California High-Speed Rail Authority

RFP No.: HSR 13-57

**Request for Proposal for Design-Build
Services for Construction Package 2-3**

Book IV, Part G.1 – Design Variance Report

**CALIFORNIA HIGH-SPEED TRAIN PROJECT
FRESNO TO BAKERSFIELD**
HANFORD SUBSECTION
ALIGNMENT H
STA. 1984+00 TO 2032+00
PLAN AND PROFILE

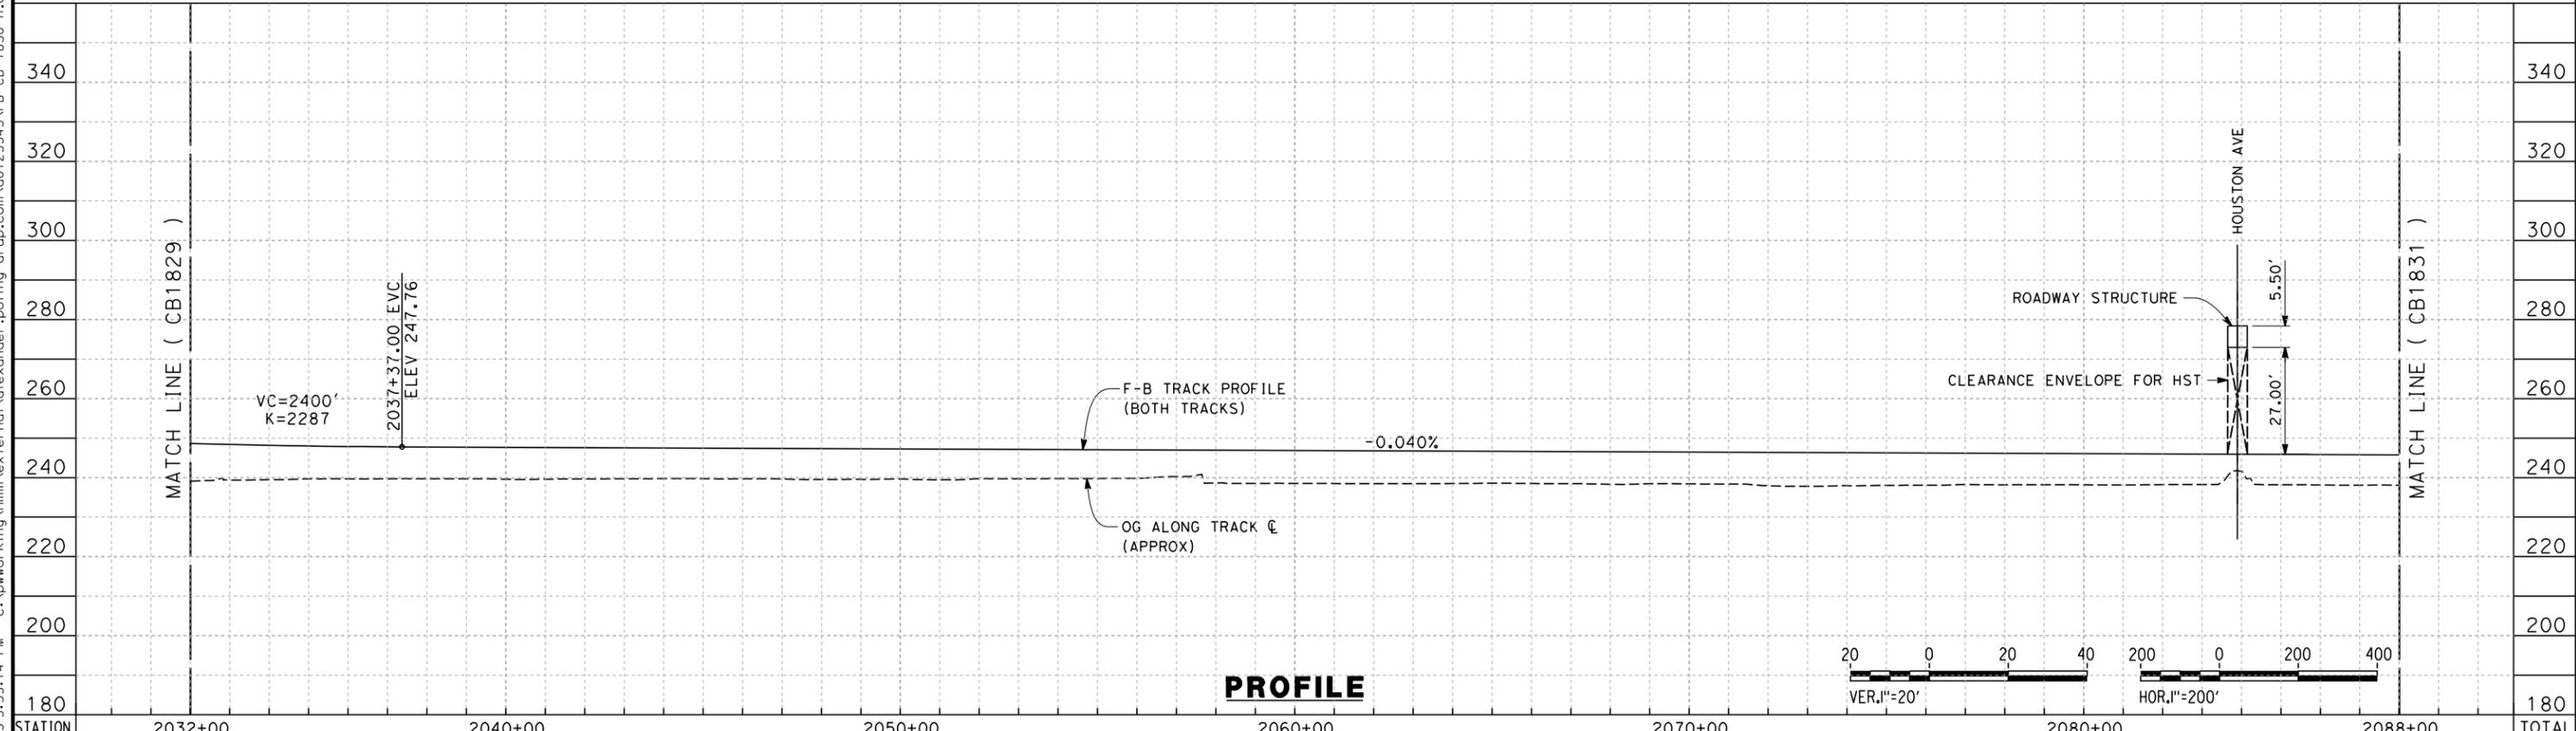
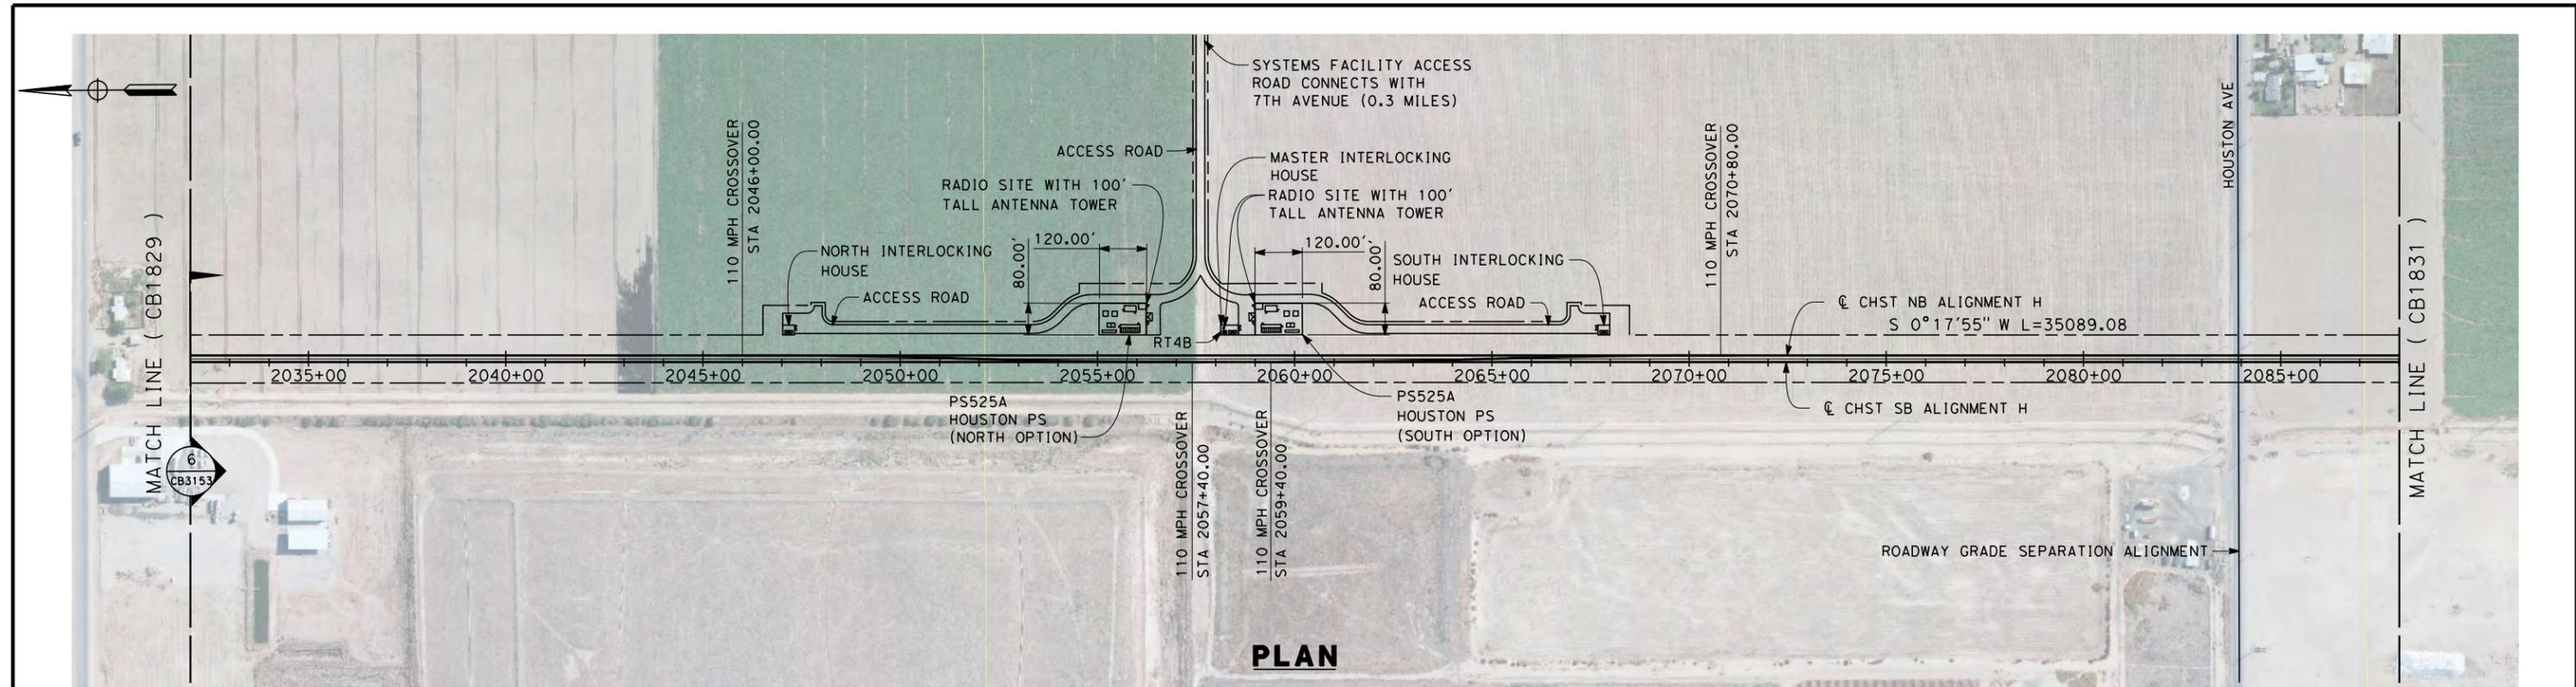
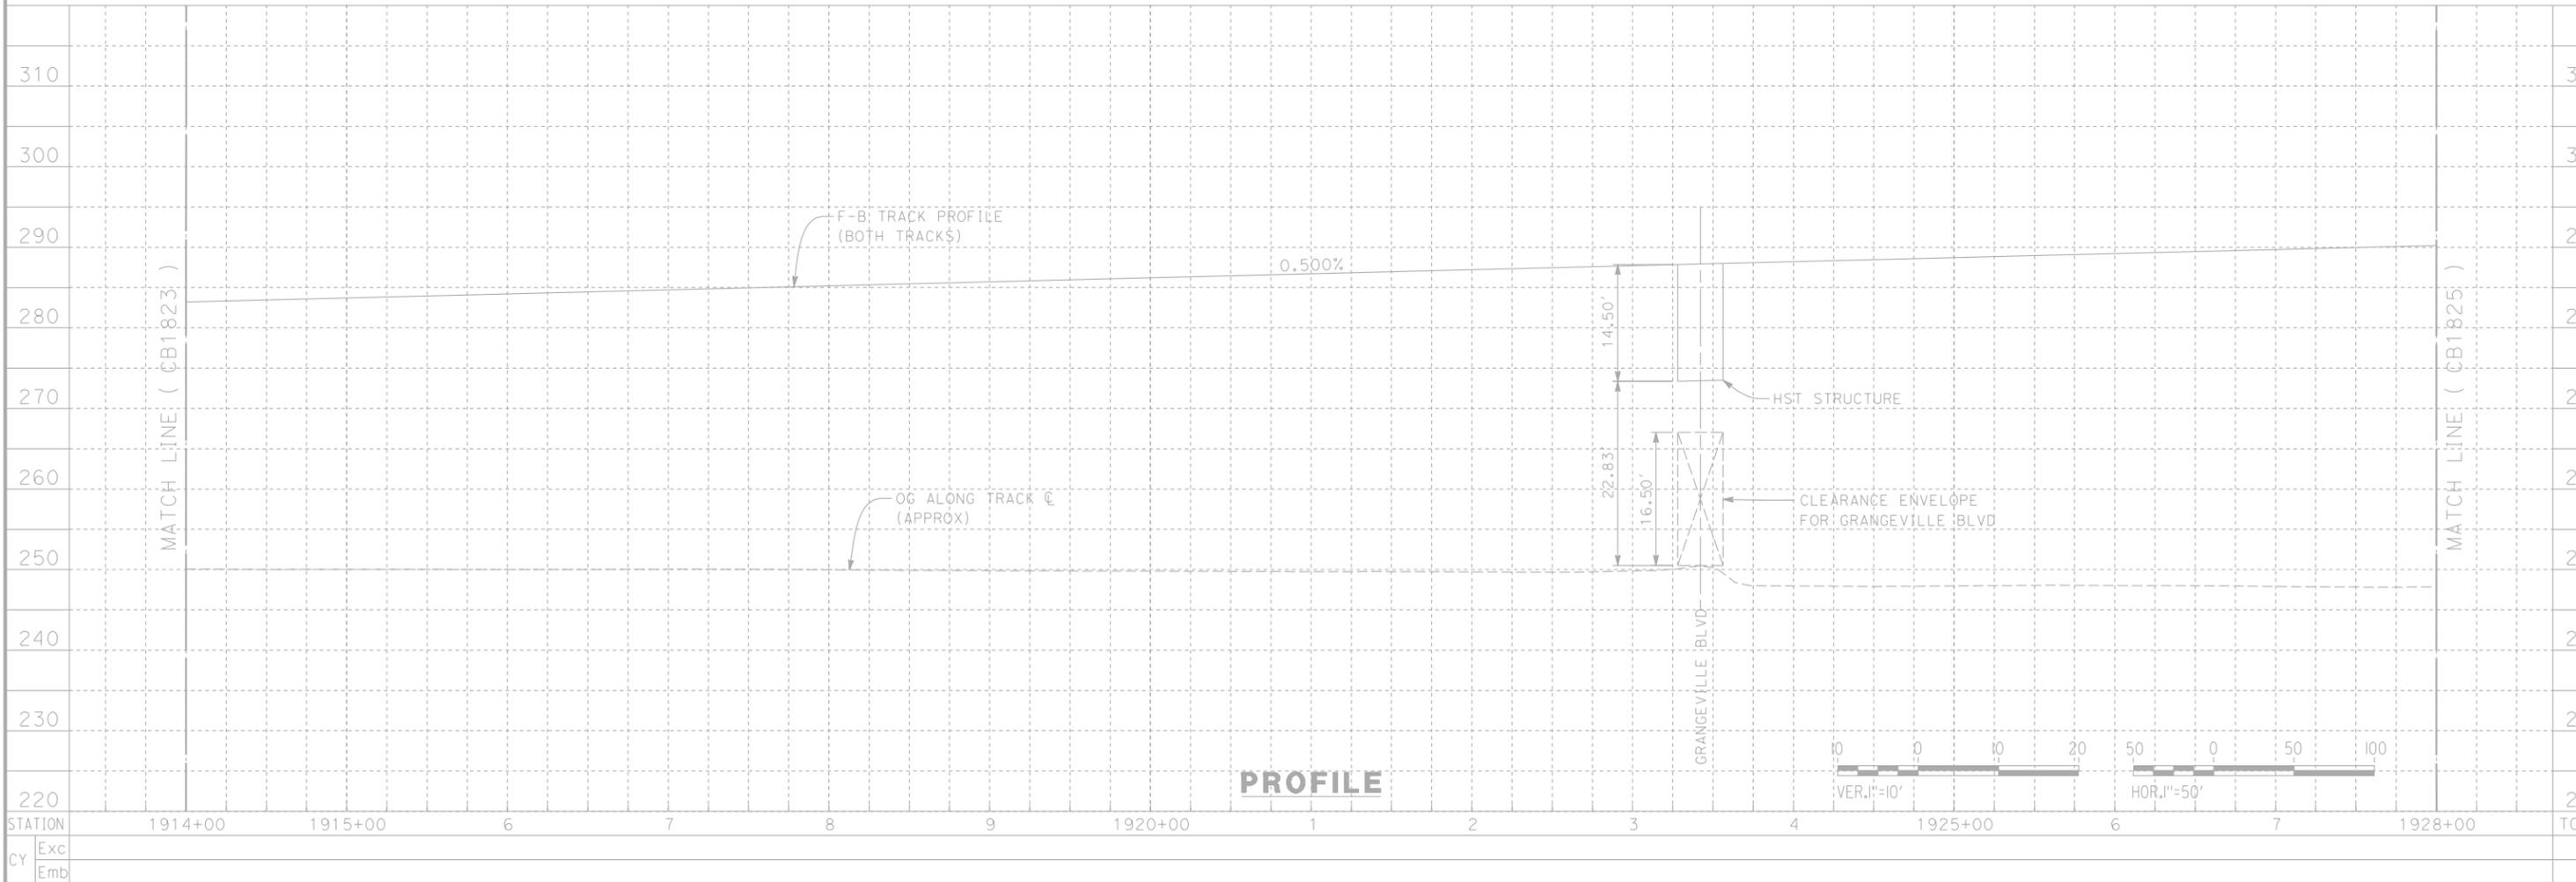
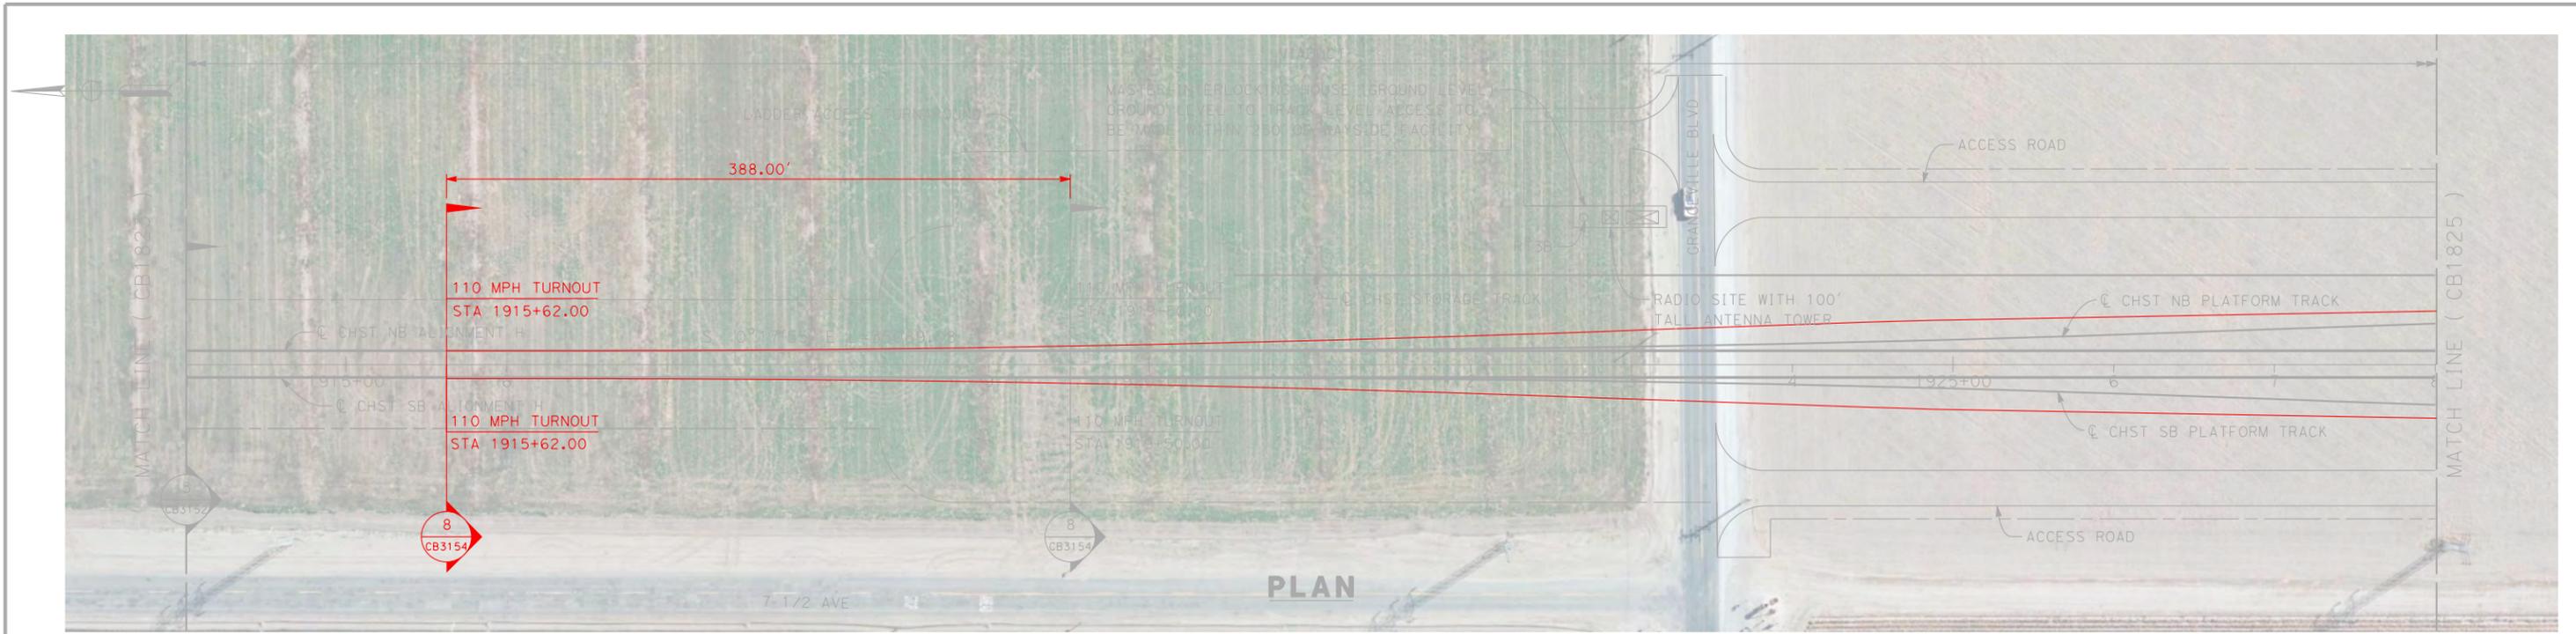
<p>REASON FOR REQUESTING A VARIANCE</p>	<p>The horizontal spiral in the return curve of the 110 mph turnout is coincident with the beginning of the vertical curve of the station tracks at all four quadrants. This does not provide the exceptional 1.5 seconds of attenuation time (242 feet) indicated in TM 2.1.2 Section 6.1.1 or the minimum 100 feet called for in TM 2.1.2 Section 6.1.7.</p>
<p>JUSTIFICATION FOR VARIANCE</p>	<p>Kings/Tulare Regional Station is raised on a viaduct and requires vertical curves north and south of the station to lower the tracks back to grade. The vertical curves are on the mainline between the turnout for station tracks and the platforms. This allows for appropriate attenuation length on the mainline and a 0% grade throughout the station.</p> <p>The 15% Record Set design provides the standard 6,000-foot station tracks at 110 mph (from point of switch to point of switch). For this length the</p>

<p>approaching the station would need to reduce speed earlier due to the turnout's location farther from the station. A design variance to Directive Drawing 2.1.3 – Interlock A would be required for the nonstandard position of the station turnouts.</p> <p><u>South of the Station</u> Desirable attenuation can be provided between the return curve spiral and the vertical curve of the station tracks south of the station by sliding the station track turnouts 610 feet south. The mainline vertical curve south of the turnouts would achieve the minimum length (1,200 feet), and the four-track viaduct would require lengthening by 610 feet. The shift south would also require relocating one system site and lengthening the access road. The distance between the station turnouts and station crossovers would decrease by 610 feet.</p> <p><u>North of the Station</u> Desirable attenuation can be provided between the return curve spiral and the vertical curve of the station tracks north of the station by sliding the station track turnouts 388 feet north. This would require lengthening the four-track viaduct by 388 feet. The shift north also requires relocation of a systems site and lengthening of the access road.</p>

OPERATIONS	None identified
MAINTENANCE	Slab track could be used to mitigate maintenance concerns of providing the station track spiral coincident with the beginning of the vertical curve.
INFRASTRUCTURE	None identified
RAILROAD SYSTEMS	None identified
OTHER	The vertical curve was located coincident with the station track spiral to avoid introducing a segment shorter than the length required to provide minimum attenuation. Ride quality may also be reduced; however, designing the two elements coincident allows the horizontal and vertical moves to occur simultaneously.
